Staff Report & Recommendation

Design Review Board

SUBJECT: DRB18-0289 (aka DRB18-0244 DRB File No. 23165)
122 West DiLido Drive

DRB18-0289 (aka DRB18-0244, DRB File No. 23165), 122 West DiLido Drive. The applicant, Travel Charter Business LTD, is requesting exterior design modifications to a previously issued Design Review Approval for a new two-story residence. Specifically, the applicant is adding an exterior stair and elevator and requesting one or more new waivers.

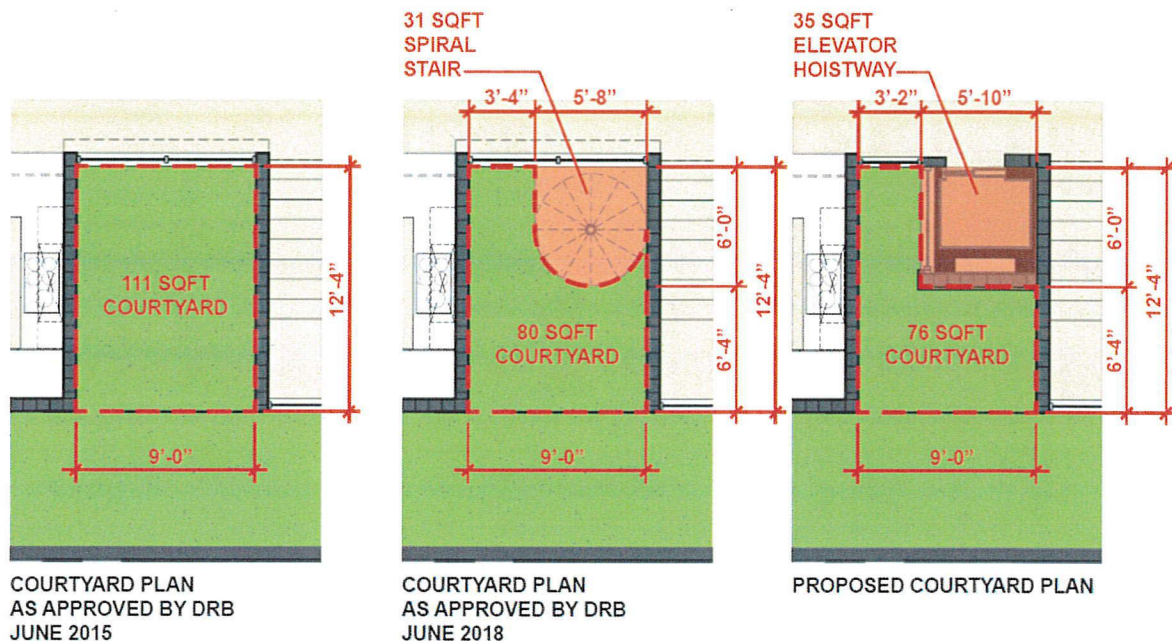
The proposed elevator will reduce the south side courtyard's open space. The approval of the exterior spiral stair at the June 2018 DRB meeting, permitted the reduced courtyard's depth from 12'-4" to 7'-0", with no overall change in lot coverage. In 2015, the south side elevation had been originally designed with the large opening recess in order to break up the façade, as outlined under Section 142-106(2)(d) of the City Code, this "open space" courtyard measured 9'-0" x 12'-4", and was fully landscaped and no waiver was needed. In

June of 2018, this open space was modified to allow a spiral stair to be placed within the open space at the second level to allow access to a new roof deck; this required a new waiver to be granted by the DRB. It is important to note that the June 2018 modifications made no changes to the ground elevation of the “open space” courtyard and it remained fully landscaped. Now, with the added exterior elevator and modification to the previously approved spiral stair, a modification of the previous design waiver is being sought. The applicant is proposing an elevator hoist way in the same position as the previously approved spiral stair. The proposed location of the exterior elevator would further reduce the courtyard’s depth from 7’-0” (12’-4”) to 6’-4” (12’-4”), with an overall increase in lot coverage of 54 SF, or .5%.

In order to satisfy the abutting neighbor’s initial concerns and the discussion by Board members at the June DRB meeting, the new revised design features an elevator with a south wall that is solid in nature, clad with wood. Landscape in the form of blue bamboo has also been added in order to better blend the new structure into the surrounding green space and creeping fig has been incorporated to grow up and along the vertical circulation element. Staff finds that the modified design—the proposed elevator—has addressed the intent of the regulation since the designated open space continues to successfully break up the massing of the two-story elevation, in more or less the same manner as the DRB modified in June of 2018. However, elevator bulkheads generally should be located as close to the center of the roof as possible in order to be visually recessive. This is not the case in this modified design. Further, the applicant is proposing a new exterior spiral stair along the south side of the home towards the rear of the house, where it will be accessed from a second floor outdoor deck, above the ground floor family room. By only rising one-story, and being relocated towards the rear of the home, the impact of the new staircase is minimized. However, the proposal needs to be modified further in its unit size calculations.

Staff has no objection to the requested modification of the open space courtyard to include an elevator. The abutting property is the sole impacted property, due to the proposed

location of the elevator shaft. As such, staff recommends a relocation of the elevator to a more central location within the site plan to provide rooftop access to wheelchair bound individuals. However, if the affected property owner to the south is supportive of the current design modification, staff will withdraw the redesign recommendation.

Based on this analysis, staff recommends continuance of the application to a future date in order to address neighbor concerns.
